CHANGE REQUEST

⌘ **33.102 CR 155** ⌘ rev **-** ⌘ Current version: **4.0.0** ⌘

Title: ⌘ Adding PS-domain specific access type codes to authentication failure report

Source: ⌘ Nokia

Figure 13: Reporting authentication failure from VLR/SGSN to HLR

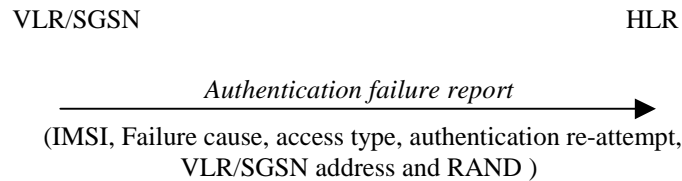
Reason for change: ⌘ The access type parameter in authentication failure report can only have values that may be used in CS-domain (e.g. location update). In addition to these, there are several access types that exist only in PS-domain (e.g. routing area update).

Summary of change: ⌘ PS-specific cases are added to the list of possible access types

1. Subscriber identity;
2. Failure cause code. The possible failure causes are either that the network signature was wrong or that the user response was wrong;
3. Access type. This indicates if the authentication procedure was initiated due to a call set up, an emergency call, a location updating, a supplementary service procedure, a short message transfer, attach, routing area updating, PDP context activation or deactivation;
4. Authentication re-attempt. This indicates whether the failure was produced in a normal authentication attempt or it was due to an authentication reattempt (there was a previous unsuccessful authentication);
5. VLR/SGSN address;
6. RAND. This number uniquely identifies the specific AV that failed authentication.
